SLOVENSKI STANDARD
SIST EN 1991-1-3:2004/oprA1:2013

Eurocode 1 - Actions on structures - Part 1-3: General actions - Snow loads

DRAFT
EN 1991-1-3:2003

prA1

Figure 5.1: Snow load shape coefficients"

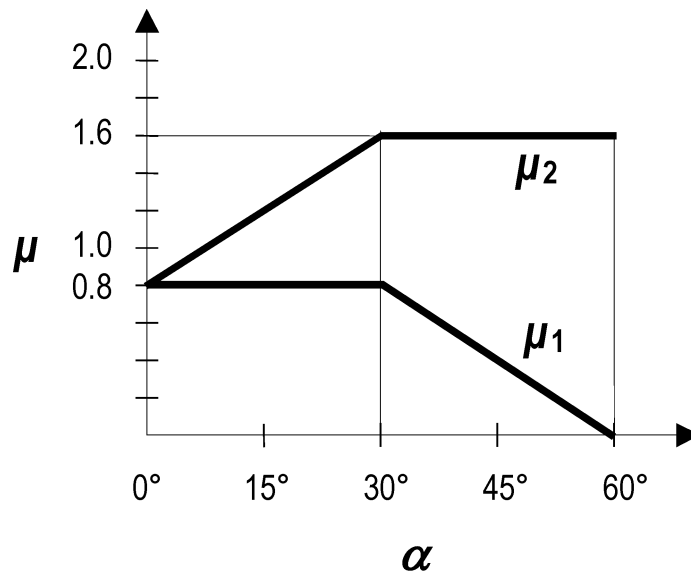
Paragraph 5.3.2(1), replace:

"(1) The snow load shape coefficient μ_1 that should be used for monopitch roofs is given in Table 5.2 and shown in Figure 5.1 and Figure 5.2."

"(1)   The snow load shape coefficient μ_1 that should be used for monopitch roofs is given in Table 5.2 and the relative load arrangement is shown in Figure 5.1.".

Figure 5.1 — Snow load shape coefficient - monopitch roof".

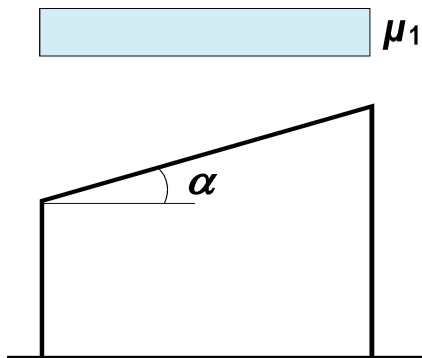
In Paragraph 5.3.2(3), replace:

Figure 5.2: Snow load shape coefficient - monopitch roof"

"(3)   The load arrangement of Figure 5.1 should be used for both the undrifted and drifted load arrangements, unless specified for the drifted load arrangement for local/specific conditions.

NOTE: Based on local or specific conditions the National Annex may specify an alternative drifting load arrangement.".

Figure 5.2 — Snow load shape coefficients - pitched roofs".

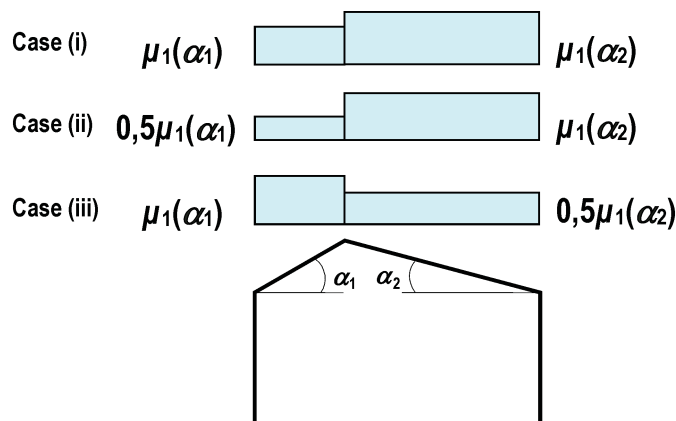
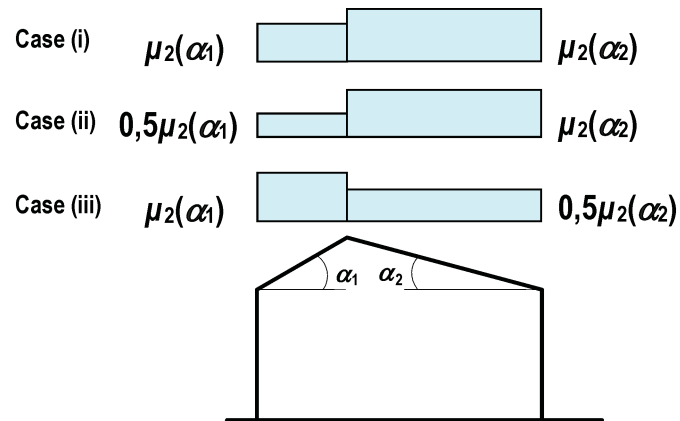
In Paragraph 5.3.3(1), replace "given in Figure 5.3, where μ_1 is given in Table 5.2 and shown in Figure 5.1." *with* "given in Figure 5.2, where $\mu_2(\alpha)$ is given in Table 5.2.".

In Paragraph 5.3.3(2), replace:

**Figure 5.3 — Snow load shape coefficients - pitched roofs"**

In Paragraph 5.3.3(3), replace "in Figure 5.3" *with* "in Figure 5.2".

Figure 5.3: Snow load shape coefficients for multi-span roofs"*.

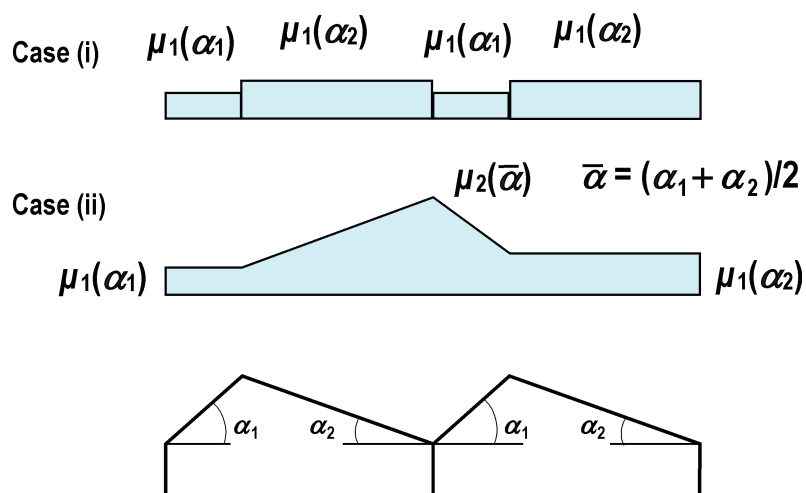
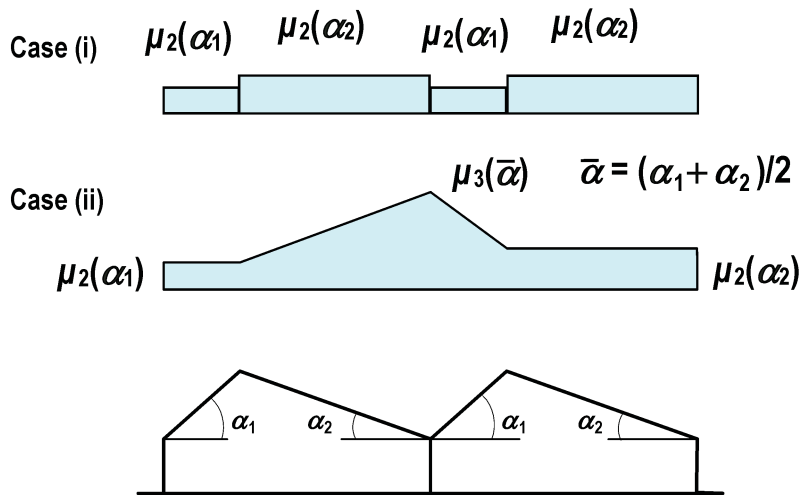
In Paragraph 5.3.4(3), replace:

**Figure 5.4: Snow load shape coefficients for multi-span roofs"**

In Paragraph 5.3.4(1), replace "in Figure 5.4" *with* "in Figure 5.3".

Figure 5.5: Recommended snow load shape coefficient for cylindrical roofs of differing rise to span ratios (for $\beta \leq 60°$)"

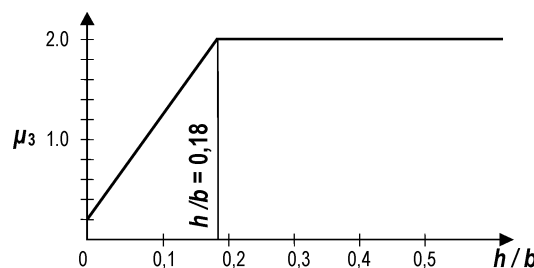
"An upper value of μ_3 should be specified.

NOTE 1: The upper value of μ_3 may be specified in the National Annex. The recommended upper value for μ_3 is 2,0 (see Figure 5.5).

"An upper value of μ_4 should be specified.

NOTE 1: The upper value of μ_4 may be specified in the National Annex. The recommended upper value for μ_4 is 2,0 (see Figure 5.4).
